**Subject:** Notice of Application- Woodinville Water District Temporary Water Main SCU16001

**Project Name:** Woodinville Water District Temporary  
Water Main

**File No(s):** SCU16001

To: Agnes Kowacz, Associate Planner  
From: Dan Fleming, Engineer I  
Date: 02/17/16  
Subject: SCU16001/Little Bear Creek (1/26/16)

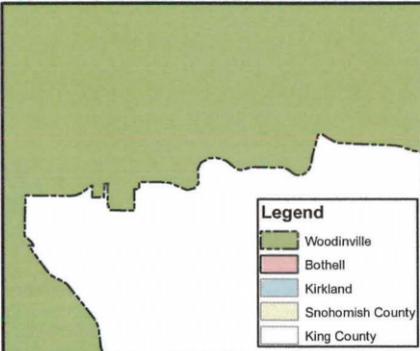
**Elaboration of erosion control measures:**

\*\*\* "...no significant trees or shrubs will be removed...Grass will be disturbed during construction but area will be reseeded after temporary bypass is removed." –SEPA checklist (#4b Plants)

Alder, Douglas-fir, red cedar, and pine are currently found on this site.

**Temporary water main installation** – keep excavation for ecology blocks to a minimum for relatively level creek crossing... stretch tarp across creek during steel beam and HDPE installation to prevent materials from entering creek... erosion control fence and straw wattles along top of bank (both sides) during installation... grass seed patch near ecology blocks/creek... silt fence will be installed in between creek and excavation sites for ecology blocks – restricting silt and coarse materials from entering waterway.

**Temporary water main removal** – proper usage of silt fence, straw wattles... removal of knotweed, dispose of materials - replace with native plants, reseed disturbed soils.
